Groundwater Application Review Summary Form

Application # G- 17937 re-review #2 GW Reviewer <u>Travis Brown</u> Date Review Completed: <u>5/9/2023</u> **Summary of GW Availability and Injury Review:** Groundwater for the proposed use is either over appropriated, will not likely be available in the amounts requested without injury to prior water rights, OR will not likely be available within the capacity of the groundwater resource per Section B of the attached review form. **Summary of Potential for Substantial Interference Review:** There is the potential for substantial interference per Section C of the attached review form. **Summary of Well Construction Assessment:** The well does not appear to meet current well construction standards per Section D of the attached review form. Route through Well Construction and Compliance Section. This is only a summary. Documentation is attached and should be read thoroughly to understand the basis for determinations and for conditions that may be necessary for a permit (if one is issued).

A. <u>GEN</u>	NERAL 1	NFO	RMATIO	<u>N</u> : App	olicant's N	ame: <u>Robe</u>	ert J. an	d E	leanor E. Sc	hmidg	<u>all</u> Co	ounty: N	Marion	
A1.				7 cfs

Water Level Trends

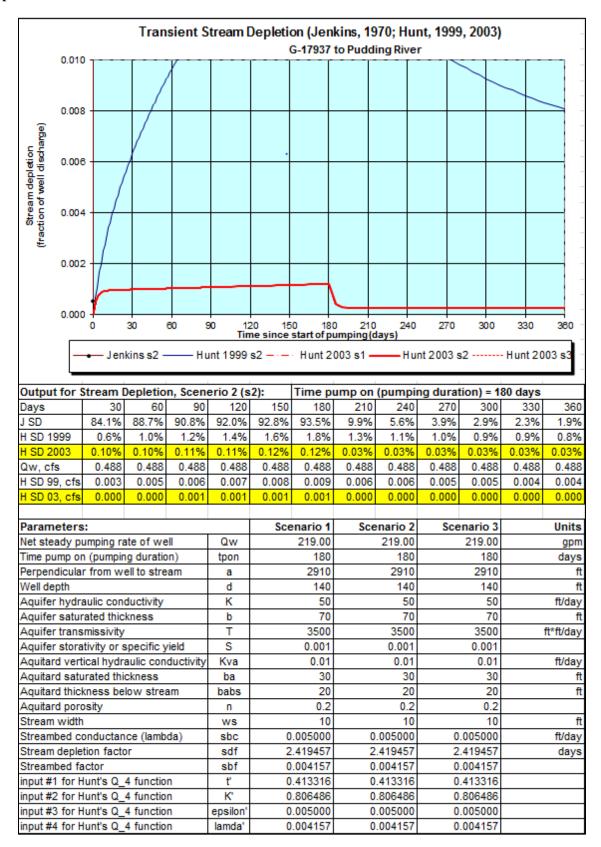
through the terrace until they flow into the Willamette River at an elevation of about 55 feet amsl, well below the top of the upper gravel layer noted in MARI 6106. Water levels in nearby observation wells suggest that groundwater levels are reasonably stable in this area. Because the productive sand and gravel beds are confined, the cone of depression from the well will spread over a broad area and may interact with multiple surface water bodies. However, more than 20 feet of saturated Willamette Silt occurs between the local surface water bodies and the productive sand and gravel beds at depth. These fine-grained sediments will decrease	surf	ace. This corresponds to elevations of approximately 140-150 feet above mean sea level (amsl). The upper surface of the
upper gravel layer noted in MARI 6106. Water levels in nearby observation wells suggest that groundwater levels are reasonably stable in this area. Because the productive sand and gravel beds are confined, the cone of depression from the well will spread over a broad area and may interact with multiple surface water bodies. However, more than 20 feet of saturated Willamette Silt occurs between the local surface water bodies and the productive sand and gravel beds at depth. These fine-grained sediments will decrease
